**SOUTHWEST ENVIRONMENTAL UTILITIES**

Re: Southwest Environmental Utilities, L.L.C. – Application for a Certificate of Convenience and Necessity (CC&N) to provide Water and Wastewater.  
Docket No. WS-20878A-13-0065  
**Compliance with Insufficiency Letter of April 22, 2013**

Subject: Southwest Environmental Utilities, L.L.C.  
CC&N Expansion

**Appendix B**  
**Conceptual Master Water Plan**

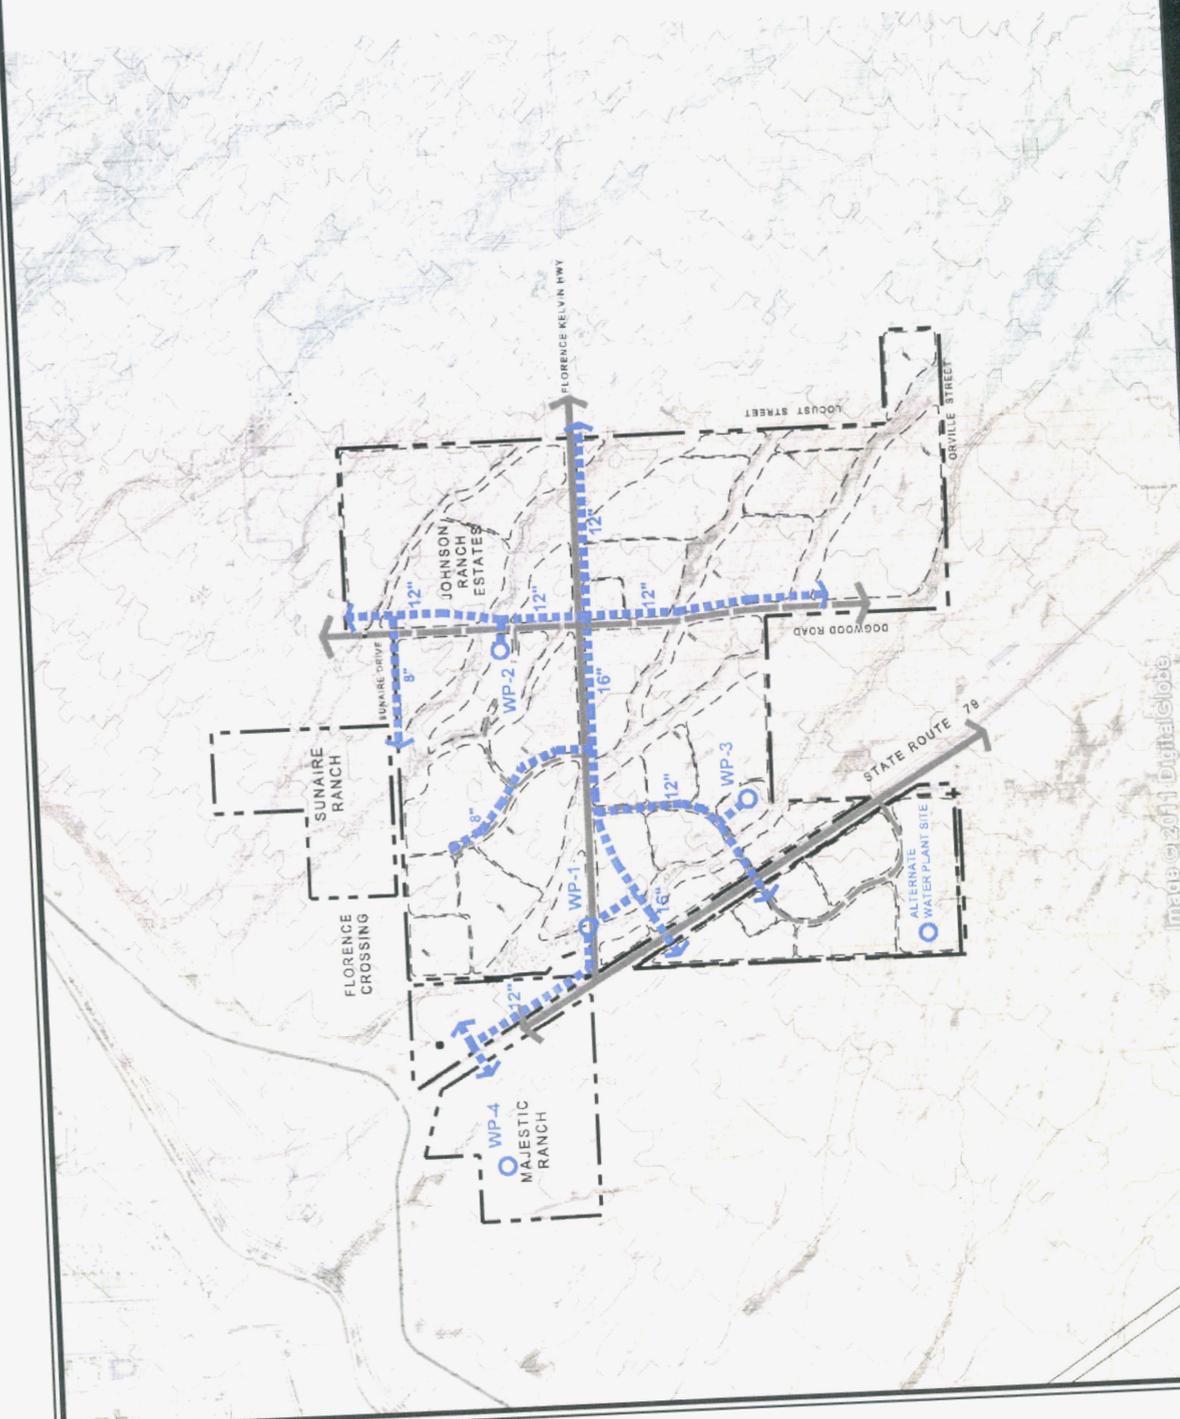
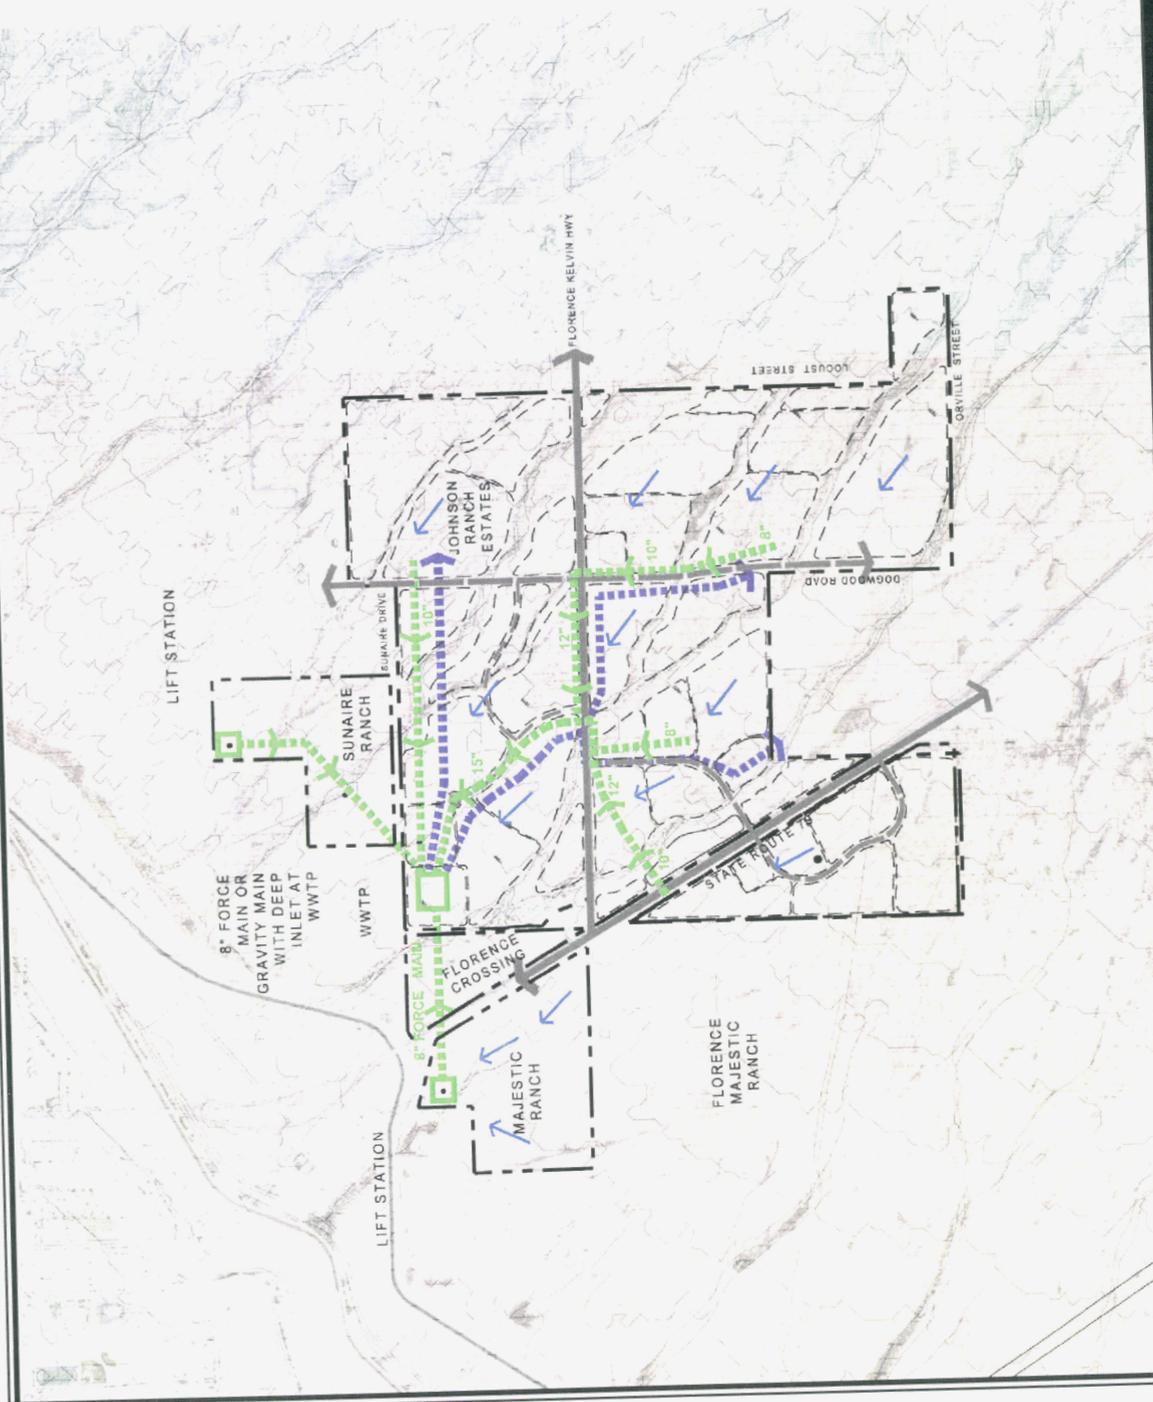
- n. A complete description of the facilities proposed to be constructed, including a preliminary engineering report with specifications in sufficient detail to describe each water system and the principal components of each water system (e.g., source, storage, transmission lines, distribution lines, etc.) to allow verification of the estimated costs provide under subsection (B)(5)(o) and verification of the requirements of the Commission and the Arizona Department of Environmental Quality can be met;

n. A complete description of the facilities proposed to be constructed, including a preliminary engineering report with specifications in sufficient detail to describe each sewer system and the principal components of each sewer system (e.g., collection mains, trunk lines, lift station, treatment plants, effluent disposal areas, etc.) to allow verification for the estimated costs provided under subsection (B)(5)(p) and verification that the requirements of the Commission and the Arizona Department of Environmental Quality can be met.

The proposed spine water system improvements are shown on the Conceptual Master Water Plan located in Appendix B of this document. This infrastructure has been designed to meet the water demand of the CC&N area.

- Production will be provided by two wells capable of producing approximately 750 gpm each.
- 2 water plants with 0.5 MG storage reservoirs and a total of 1,225 gpm of booster pumping capacity.
- Water will be distributed via 8", 12" and 16" mains totaling approximately 13,000 linear feet.

- Production will be provided by a total of four wells capable of producing approximately 750 gpm each.
- 4 water plants totaling a minimum of 2.0 MG of storage reservoirs with a total of 4,530 gpm of booster pumping capacity.
- Water will be distributed via 8", 12" and 16" mains totaling approximately 24,000 linear feet.
